UNITED STATES OF AMERICA
NUCLEAR REGULATORY COMMISSION

In the Matter of) Docket No. 50-275
PACIFIC GAS AND ELECTRIC COMPANY) Facility Operating License
) No. DPR-80
)
Diablo Canyon Power Plant) Docket No. 50-323
Units 1 and 2) Facility Operating License
) No. DPR-82

License Amendment Request
No. 98-01

IMPLEMENTATION OF 230 KV SYSTEM IMPROVEMENTS

FIGURE 8.2-1
OFFSITE SINGLE LINE DIAGRAM

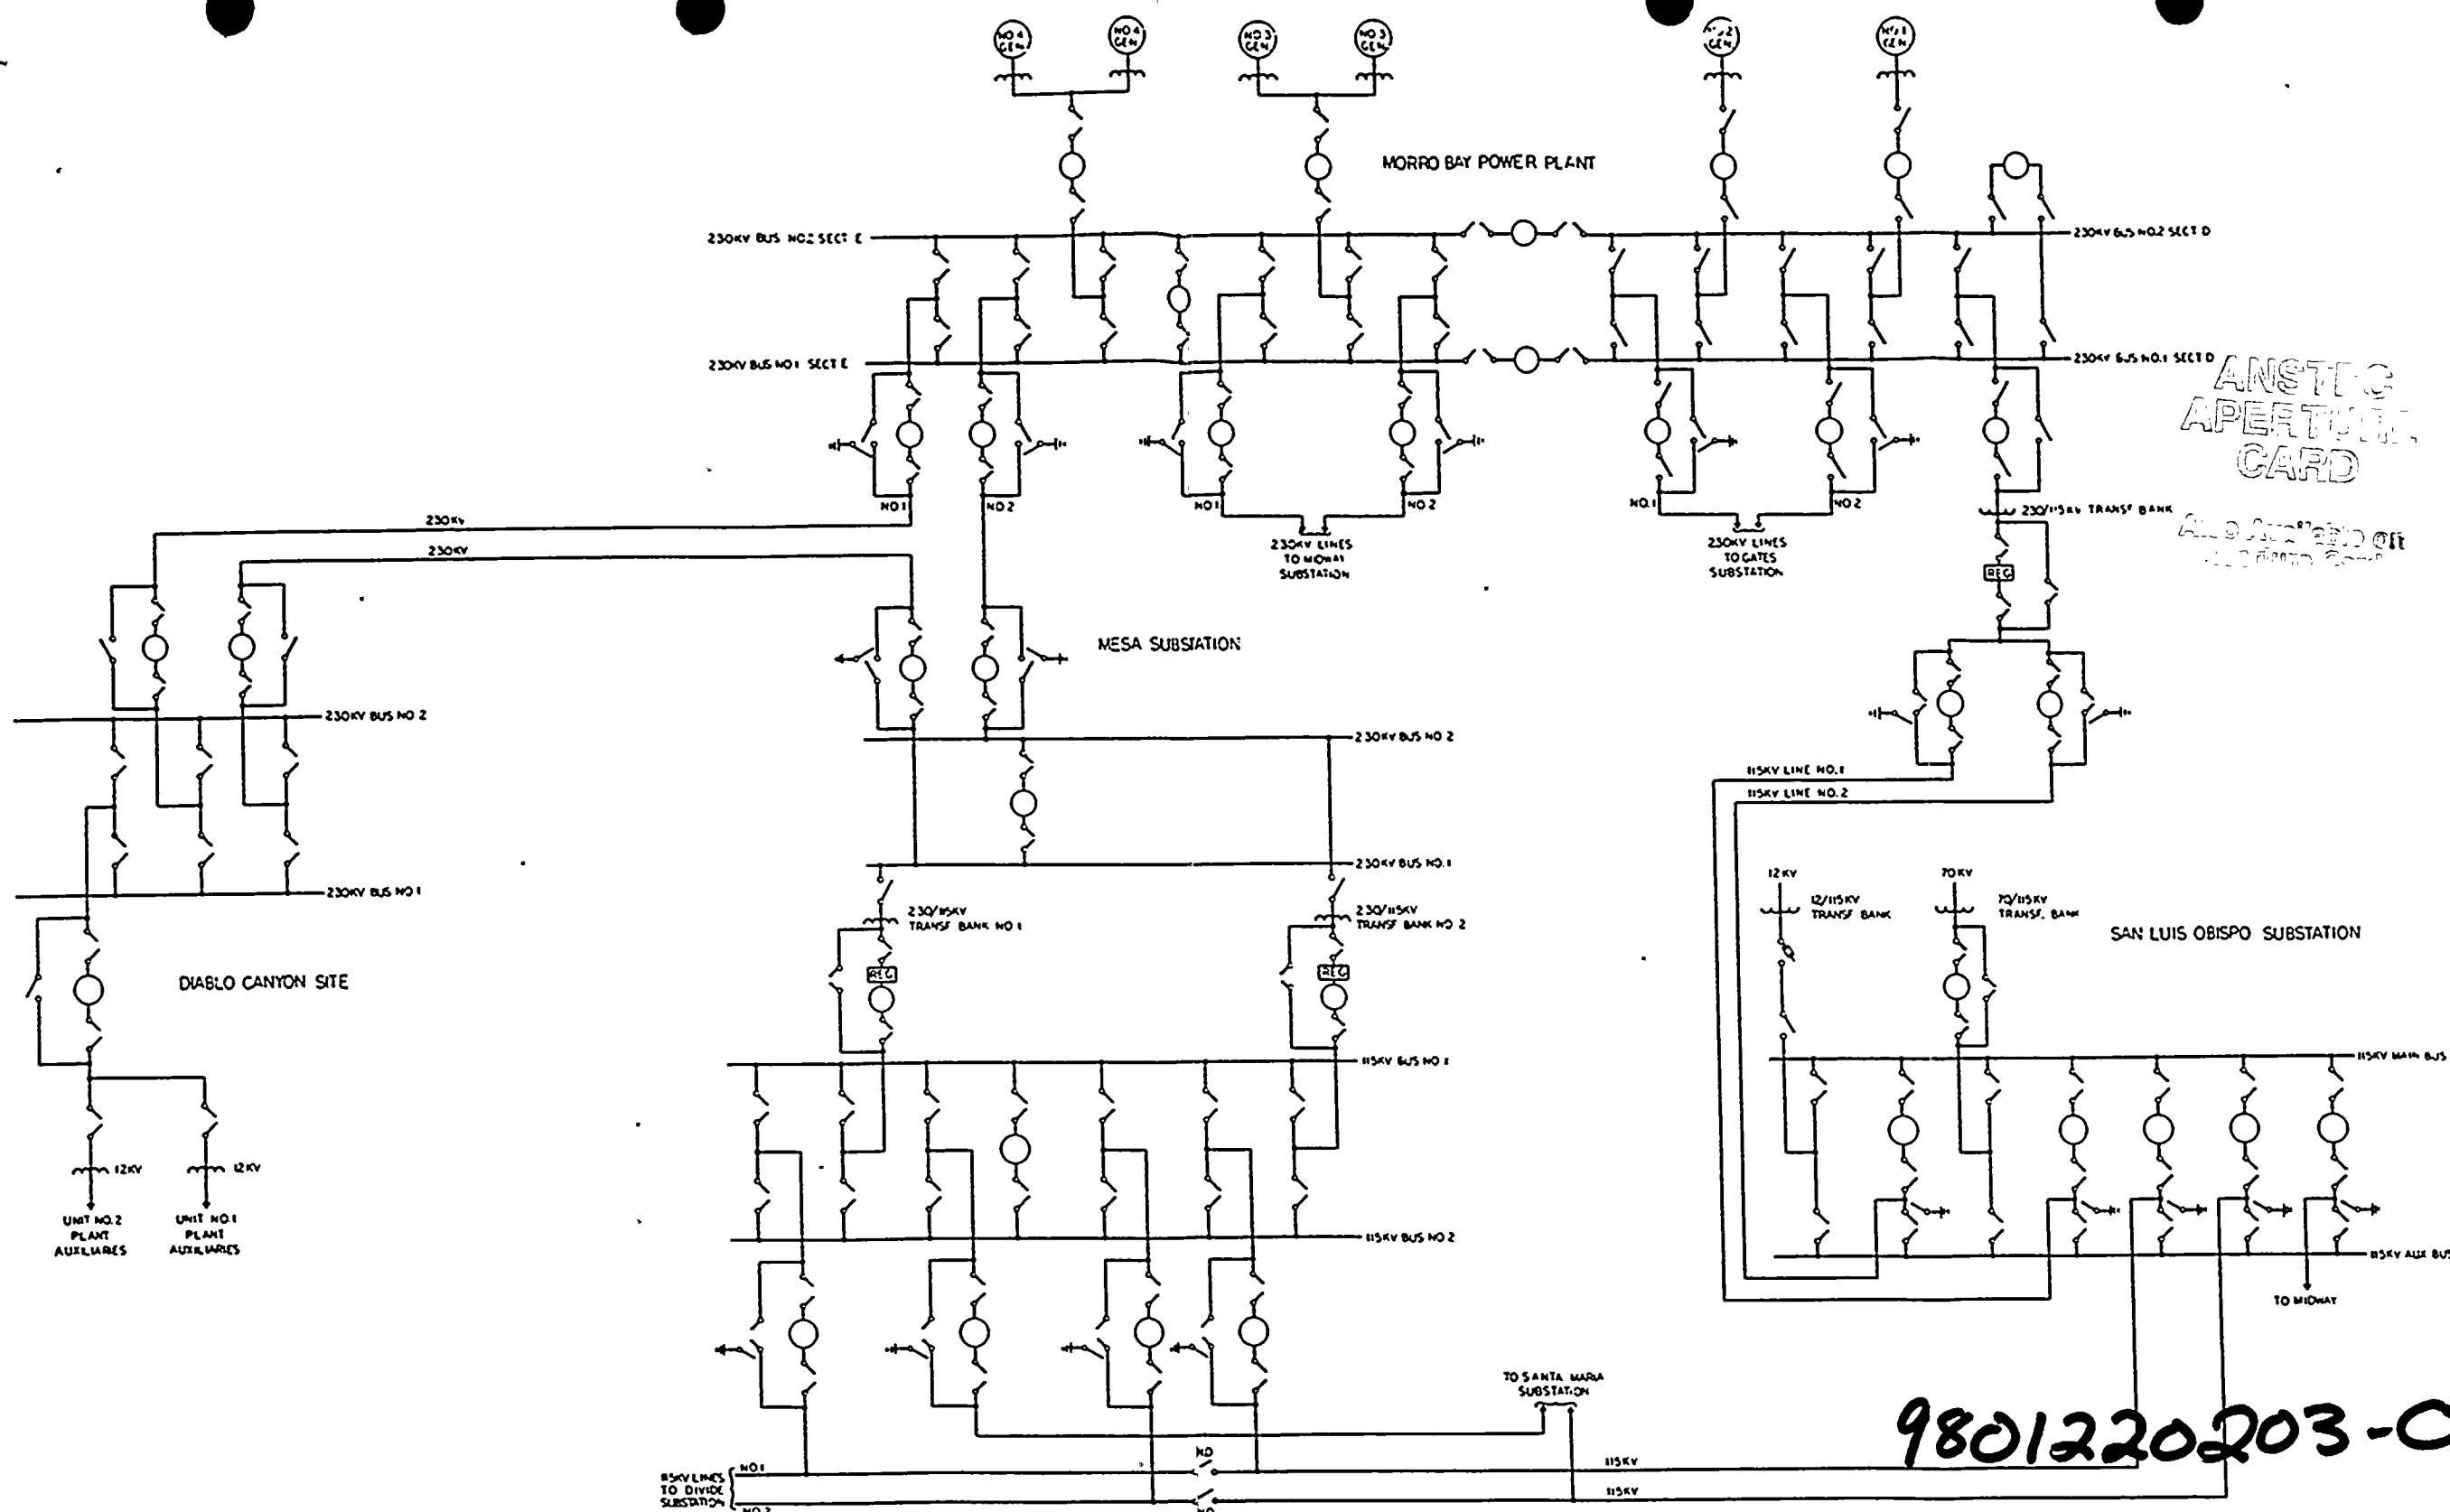
Offsite power (see Figure 1) for startup and standby service is provided from the 230 kV transmission system. The two incoming 230 kV transmission lines, one from the nearby MBPP switchyard, approximately 10 miles away, and the other from the Mesa Substation, feed a 230 kV switchyard having three 230 kV circuit breakers, one for each line and one for the standby startup transformers. Offsite power to the plant auxiliary systems and engineered safety feature (ESF) buses can also be provided from the 500 kV system when the main generator is not in operation. The 500 kV line is a backup for the 230 kV plant power supply via the main transformer to the unit auxiliary transformers.
